Planning consultation - WSCC/005/24 Buckingham Park Primary School, 15% of the perimeter, Shoreham-By-Sea BN45 5UD 07 March 2024 17:22:00

Having viewed the details for planning application no. WSCC/005/24 for the erection of two temporary classroom blocks on existing playground with access from existing site compound, Additional information is required to show suitable access for a fire appliance to within 15% of the perimeter or within 45m of every point of the footprint of the building, which ever is the less onerous. There is insufficient information showing the access route.

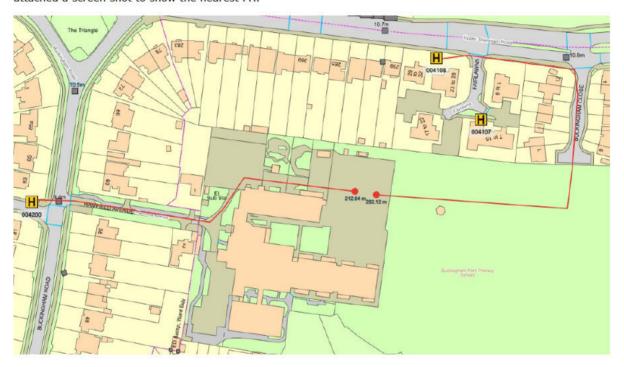
Also, evidence is required to show the location of the supply of water for firefighting, the nearest accessible fire hydrant to the two temporary classrooms is 212m away, 122m further than the 90m requirement, I have attached a screen shot to show the nearest FH.

As these two temporary classrooms are not within the 90m requirement, information is required to show what control measures will be put in place to compensate for this shortfall. Although AD-B mentions any new build with a compartment size less than $280m^2$ does not need an additional fire hydrant, it does not say how water will be provided when the nearest FH is over 200m away, but the new build does not have a compartment size over $280m^2$. Water is always required to extinguish a fire unless a suppression system is to be installed as mitigation.
